PILOT-SCALE TREATABILITY STUDY WORK PLAN STEAM ENHANCED EXTRACTION SITE 13 NAVAL AIR STATION ALAMEDA ALAMEDA, CALIFORNIA

Revision 1

UNCLASSIFIED March 20, 1996

Figure 7-4: Injection/Extraction Well Design

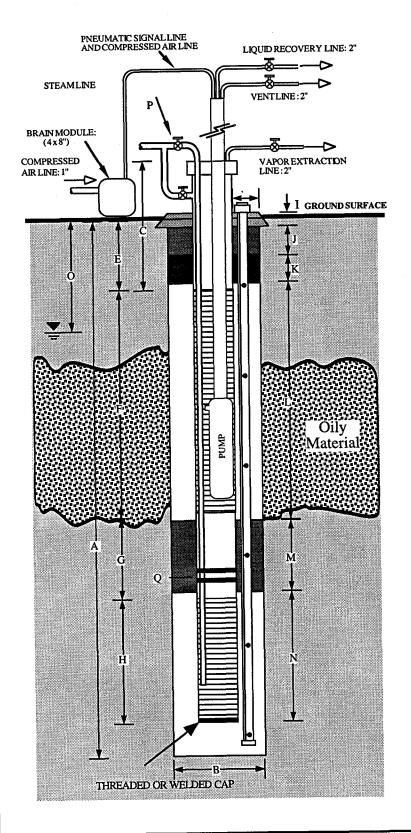
Comment 33: The injection/extraction well diagram does not show a pump in the well for liquid removal. It is not clear from text or figure 8.3, how liquid is pumped from the well.

Response 33: The location of the pump has been added to Figure 7-4 of the final Work Plan and a diagram of the planned well pump is included as Figure 7-5 of the final Work Plan. The pump may be raised and lowered in the well.

Program Management Organization Chart

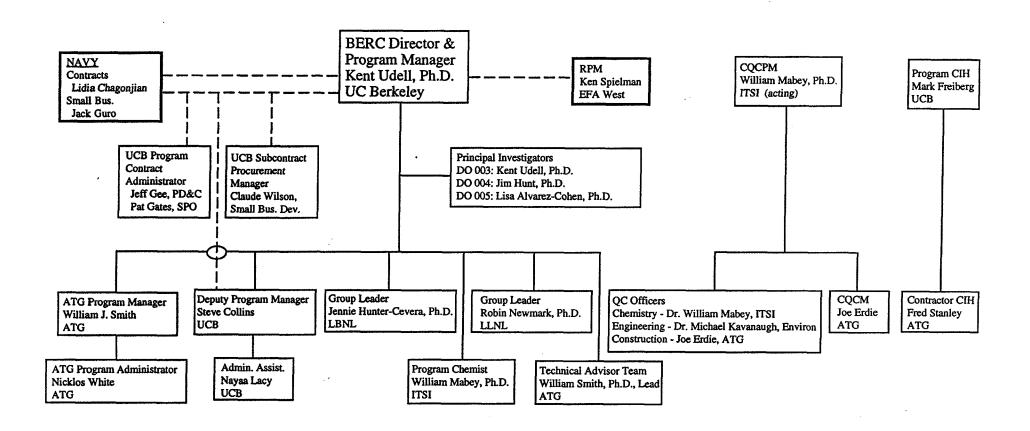
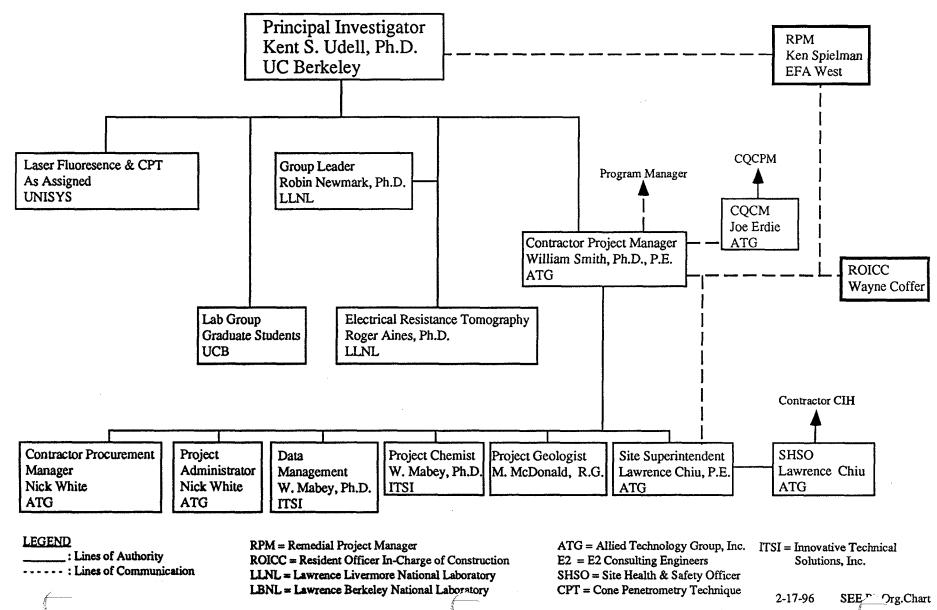
Comment 2: Figure B-1: The project organization chart indicated the QC functions are subordinate to the E2 project manager which is not allowed; the QC should be independent and work under the UC CQC program manager with all QC related functions under the project CQC manager separate from the construction production effort. The chart should also identify the necessary submittal reviewer and approval requirements, testing labs and consultants related to QC.

Response 2: The organization chart has been revised in response to this comment. Program and project organization charts are provided on Figures 2-1 and 2-2 of Contractor's Quality Control Plan (CQCP), Appendix D to the final Work Plan.
